AIA[®] Document G710[™] – 2017

Architect's Supplemental Instructions

PROJECT: *(name and address)*
57-21113-00 - Rebid Dutchess Stadium
New Left Field Clubhouse, Seating Bowl,
& Restroom Building

ASI INFORMATION:
ASI Number: 005

1 SIGNAL BLOCK DIAGRAM - VIDEO DISTRIBUTION
TA6.04i SCALE: 12" = 1'-0"

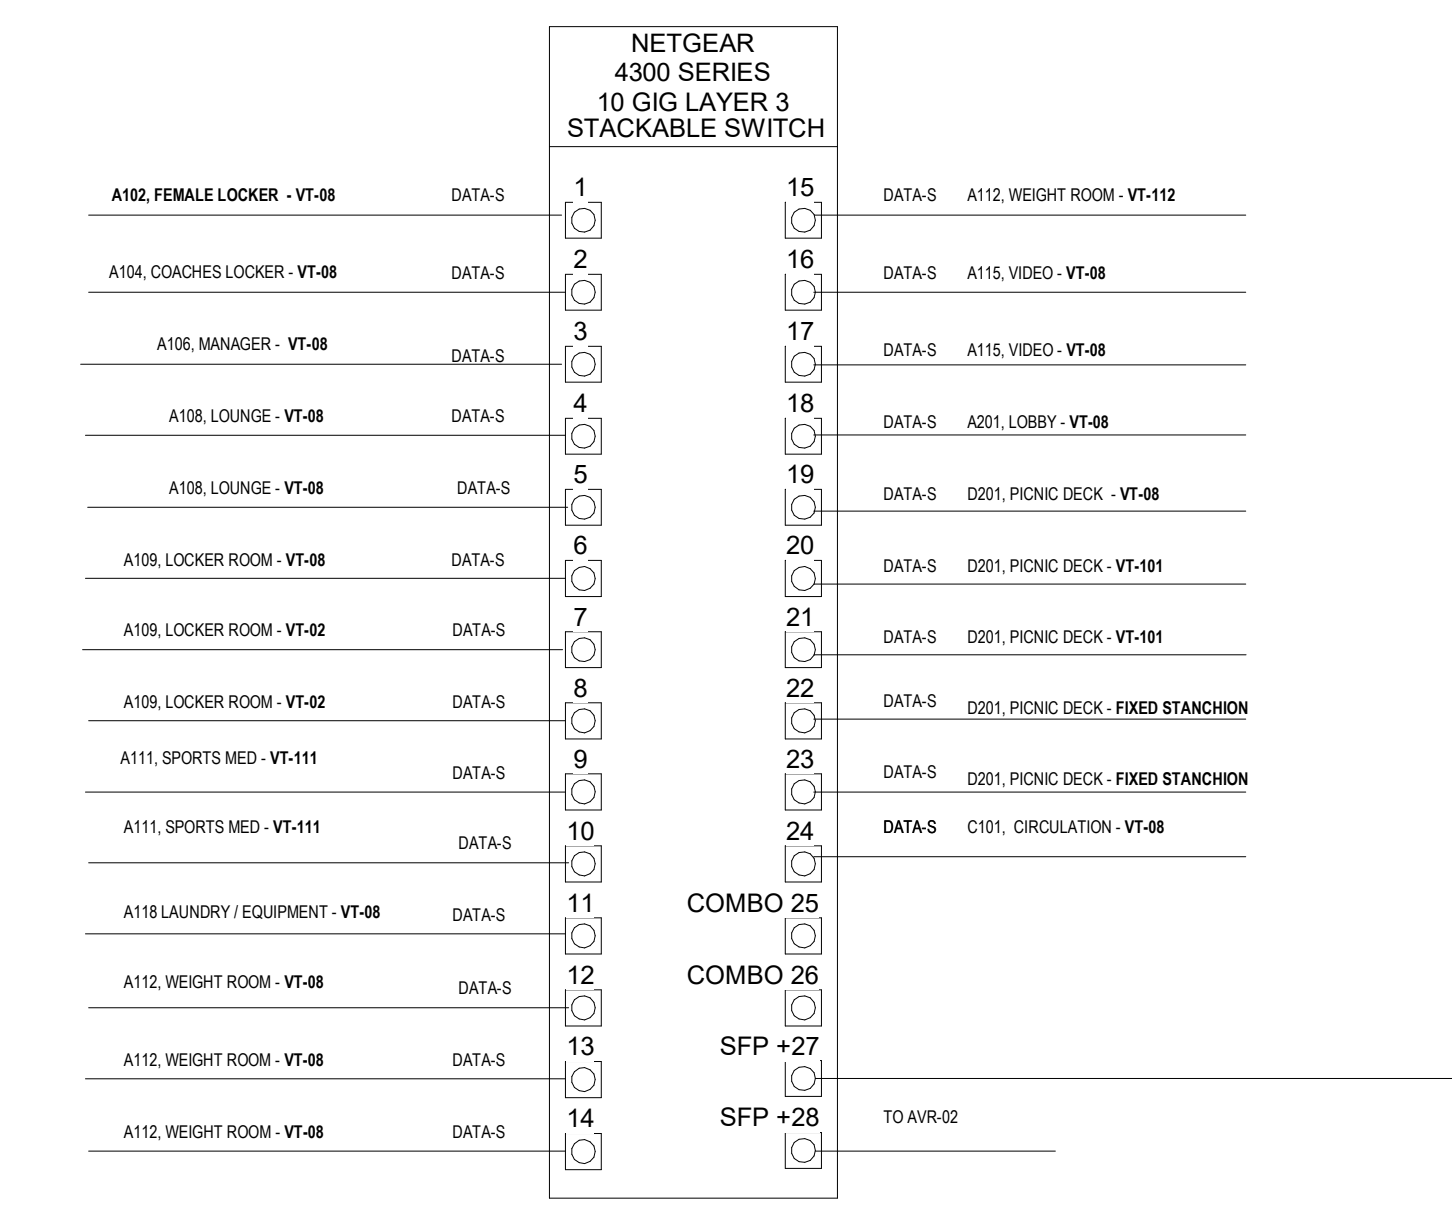
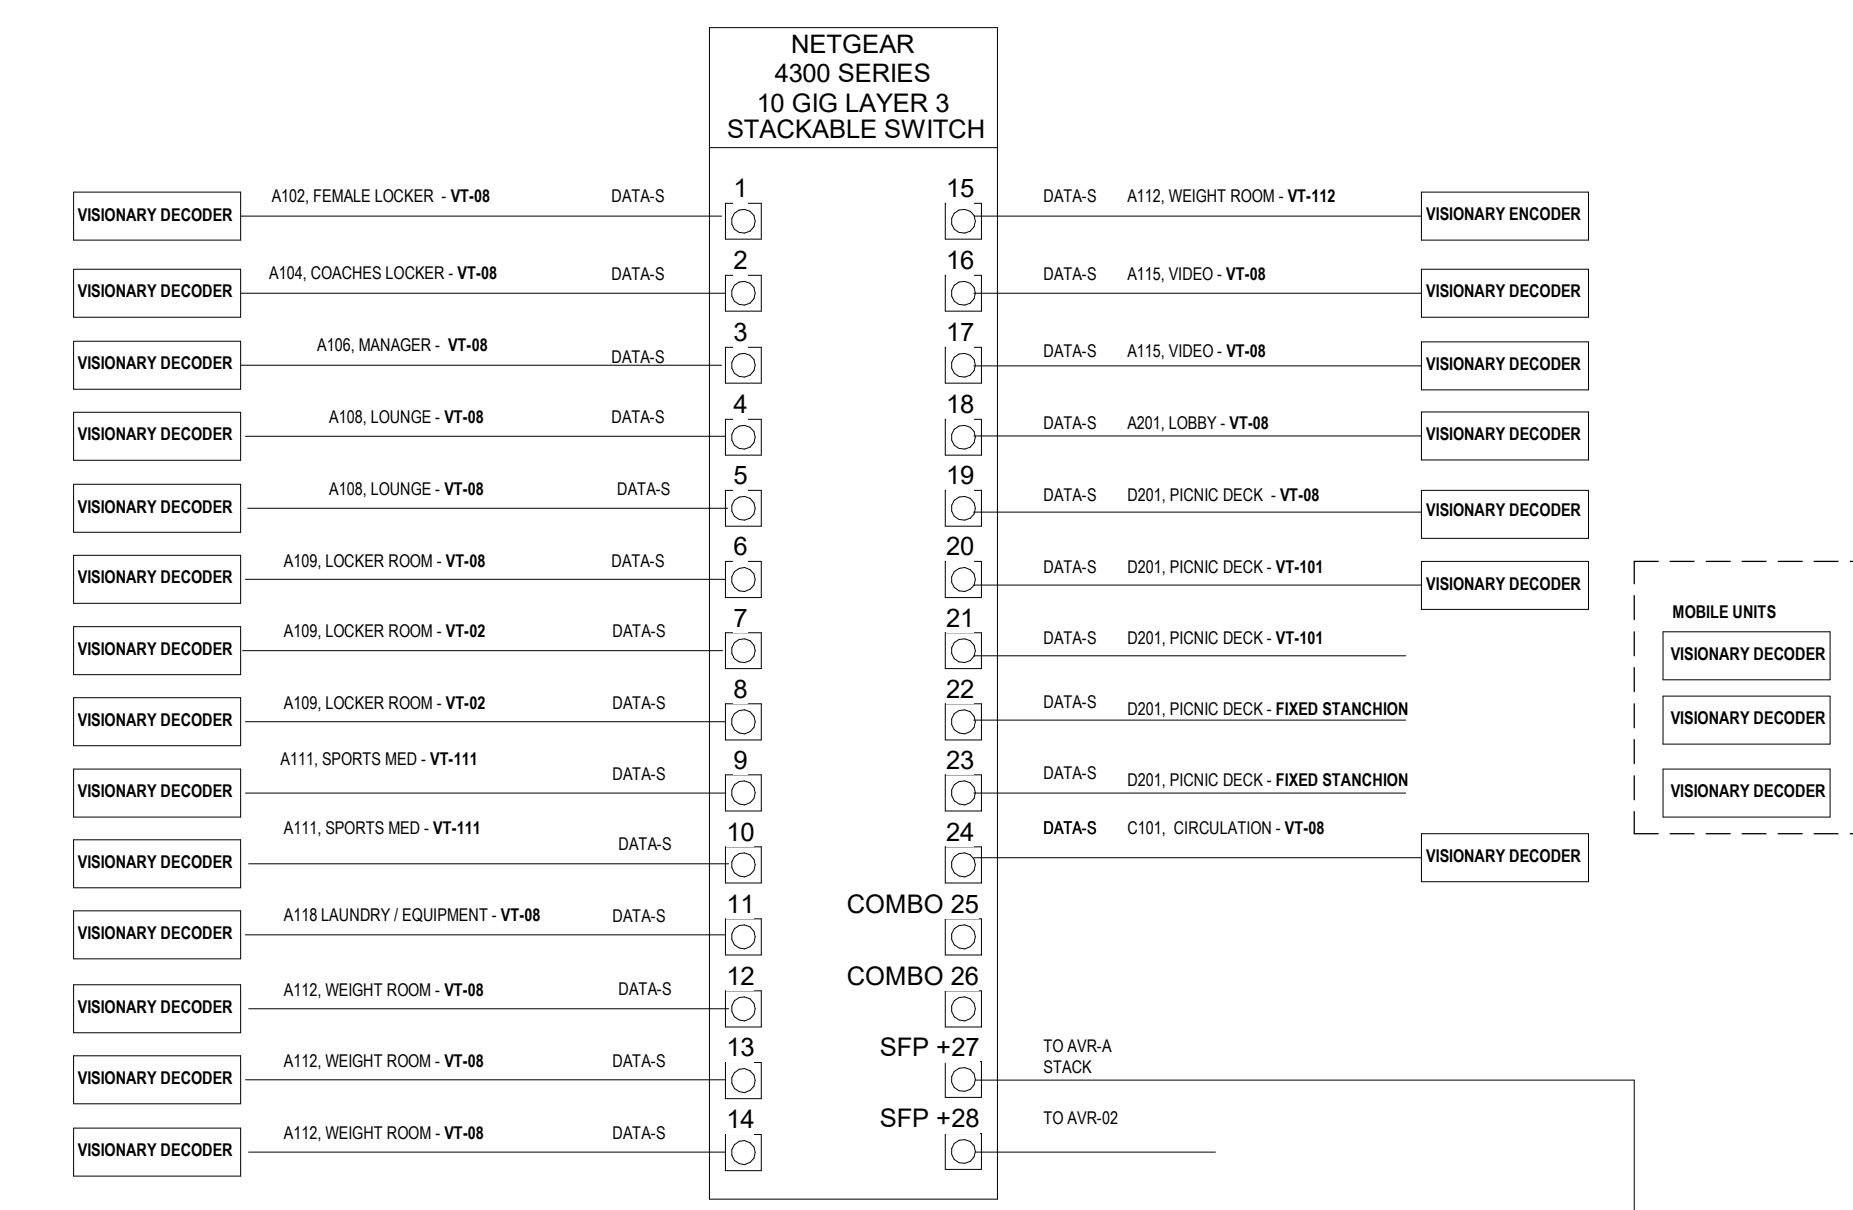
- a. Modifications per the attached sheet.
21. Sheet TA6.01.ii AUDIOVISUAL SYSTEM BLOCK DIAGRAM, CLUB LEVEL OPTION A
 - a. Delete in its entirety.
22. Sheet TA6.04ii - AVR-A, AUDIOVISUAL VIDEO SIGNAL BLOCK DIAGRAM

- a. Add per the attached sheet.
23. Sheet TA6.03.ii INTEGRATED AUDIO SYSTEM BLOCK DIAGRAM
 - a. Delete in its entirety.
24. Sheet TA6.05ii - AVR-A, SUPPLEMENTAL VIDEO SIGNAL BLOCK DIAGRAM

1 AVR02 VIDEO SIGNAL BLOCK TERMINAL
TA6.06j SCALE: 12" = 1'-0"

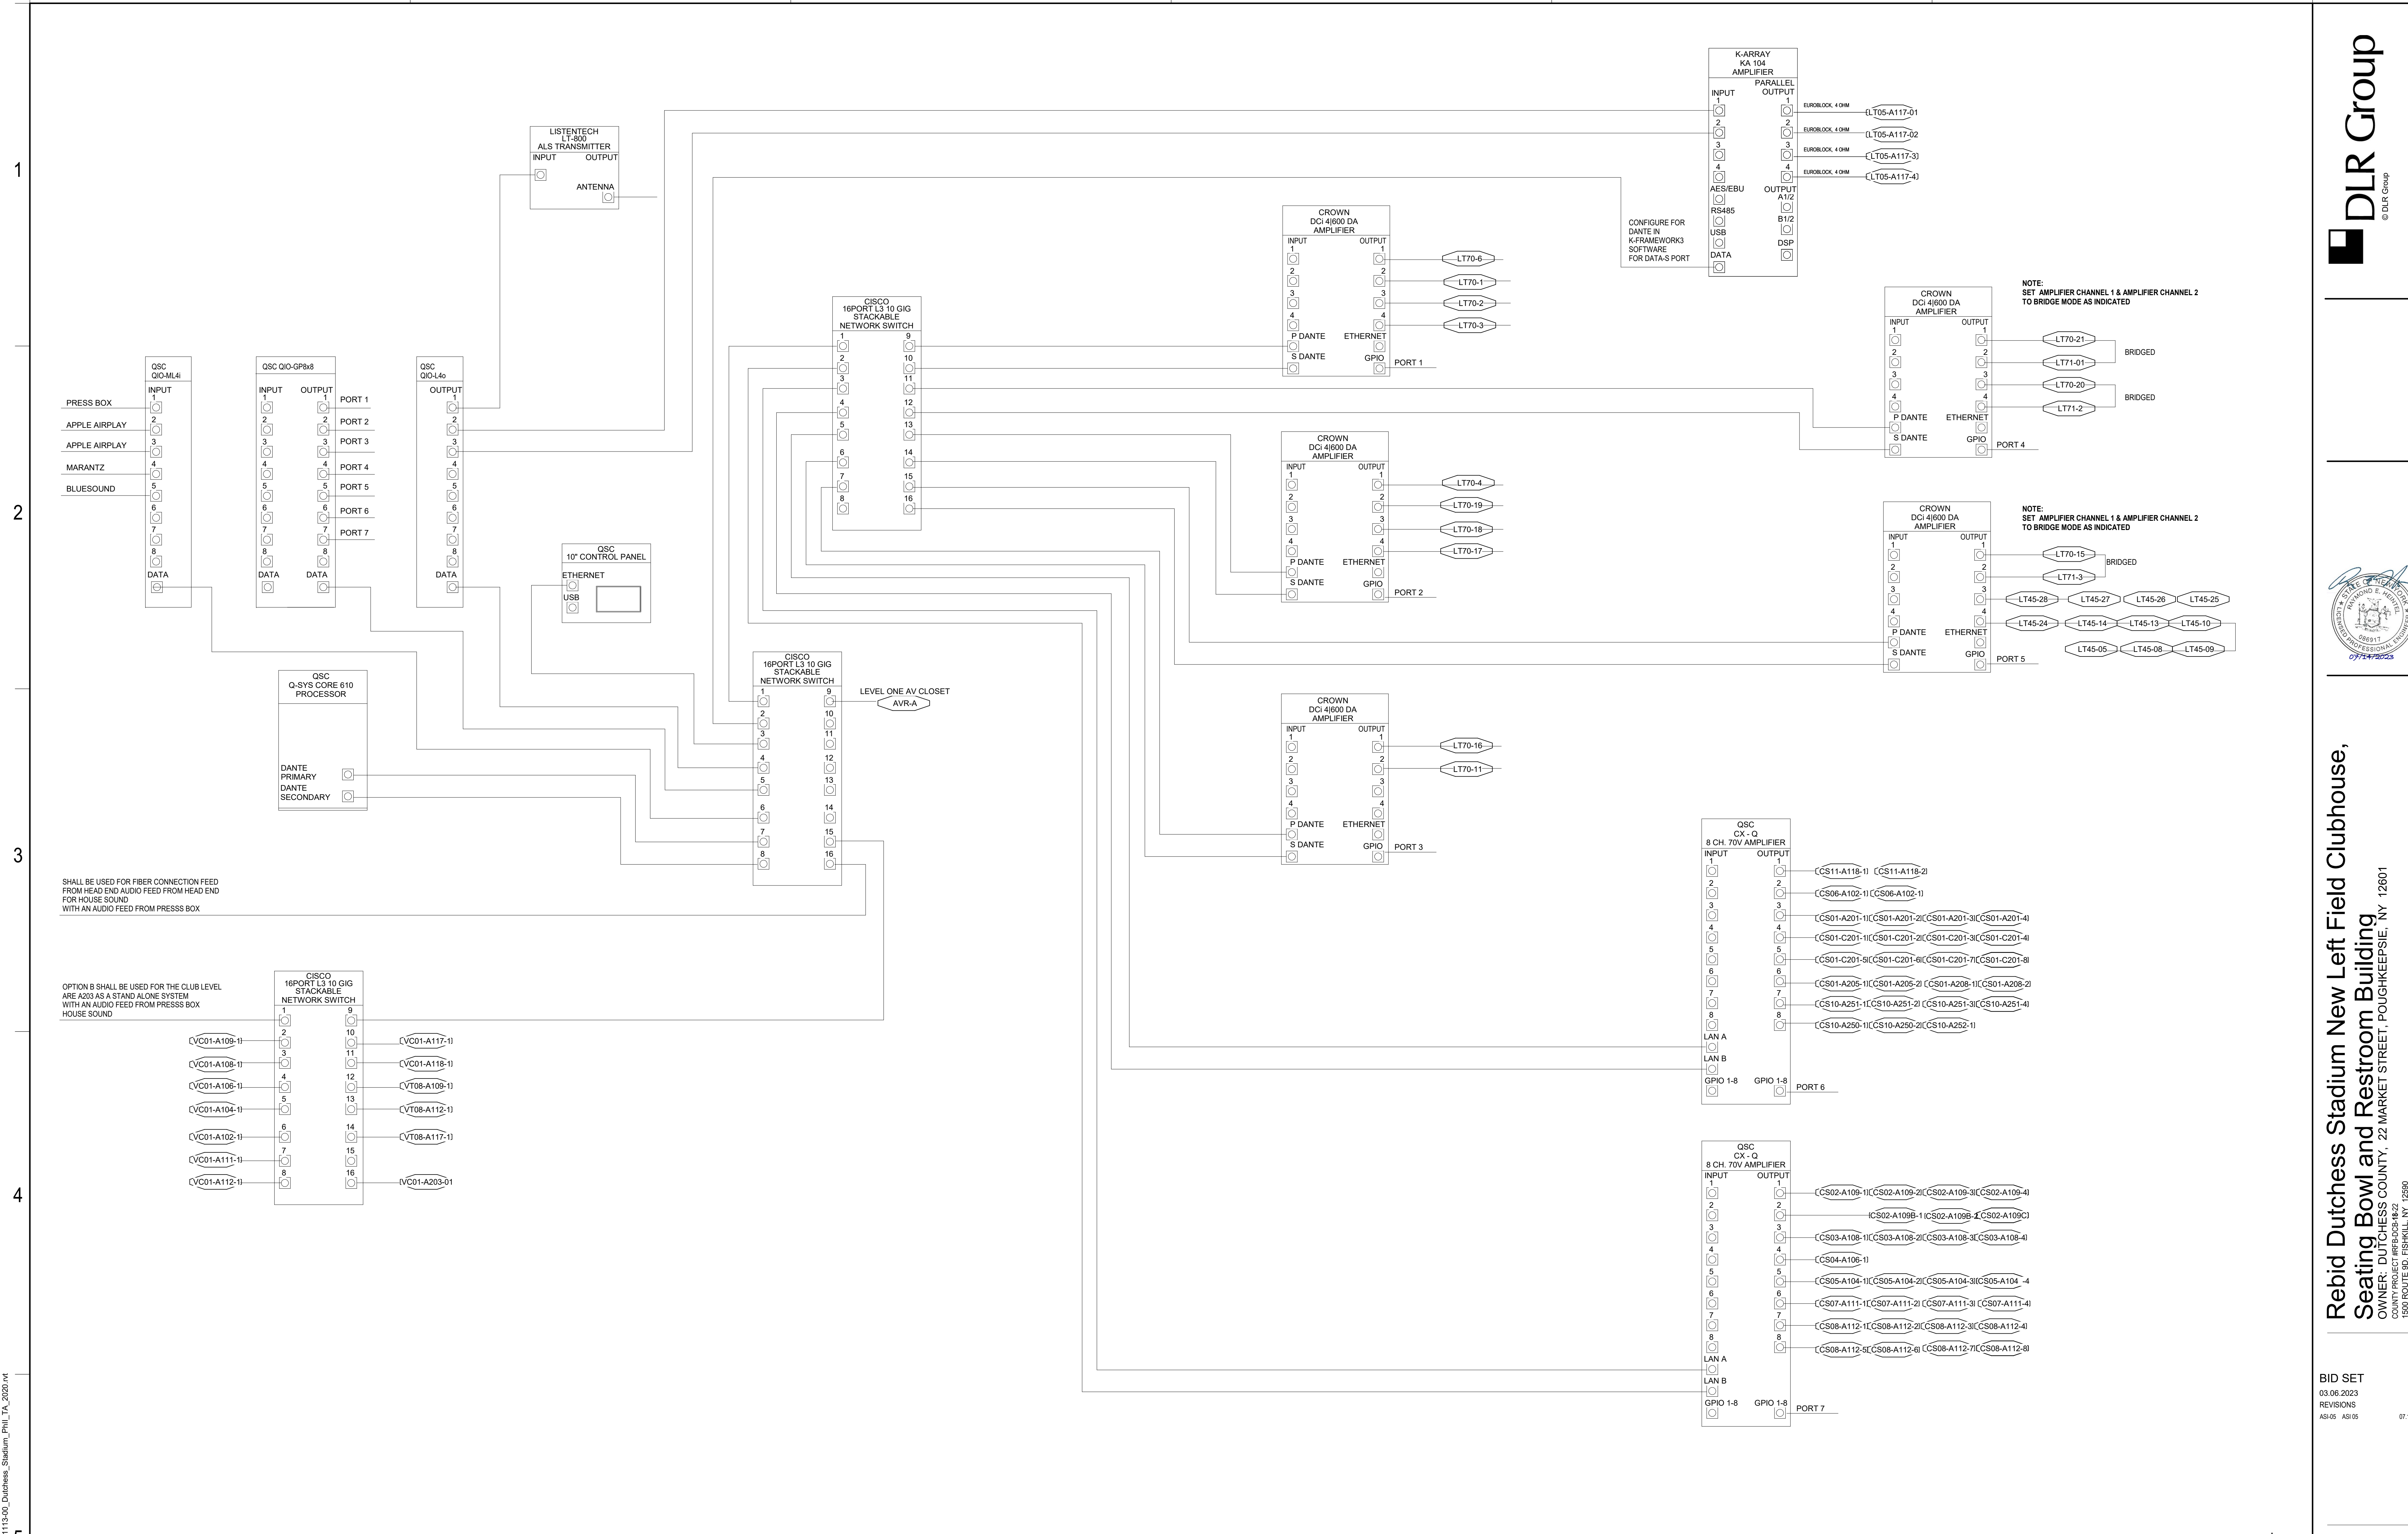
- a. Add per the attached sheet.
25. Sheet TA6.06ii - AVR-A, CLUB LEVEL VIDEO SIGNAL BLOCK TERMINALS
 - a. Add per the attached sheet.
26. Sheet TA6.07ii - AVR-A, AUDIO SIGNAL BLOCK DIAGRAM
